Access Compliance Report

Public Rights-of-Way

(Pedestrian Signals)

Intersection ID: N/A	Main Street:	Cross Street: N/A	Location: N/A
ADA ID: 030CAE9E67A0	Signal Type: One Push Button-APS	Overall Compliance: No	Severity Score: BTN 1: N/A BTN 2: N/A No BTN: N/A
Codes/Mitigation Info/Possible Solution		Field Measurements/Component Compliance

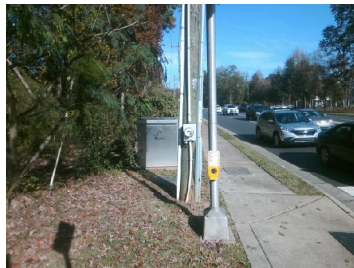
PROW/ADA: TMUTCD 4e.08, R404.2, R404.3, R404.7.3, R209.1, MUTCD 4e.10

Yes B 1 Clear Xing Direction?	ClearlyMarked	N/A B 2 Clear Xing Direction?	N/A
B 1 Crossing Direction	To E	B 2 Crossing Direction	N/A
Yes B 1 DistanceTo XWalk (in)	0.0	N/A B 2 DistanceTo XWalk (in)	N/A
No B 1 DistanceTo Curb (in)	96.0	N/A B 2 DistanceTo Curb (in)	N/A
Yes B 1 Diameter (in)	2.0	N/A B 2 Diameter (in)	N/A

Possible Solutions: Replace Signal Push Button With APS Button on New Post. Remove & Relocate Sign.
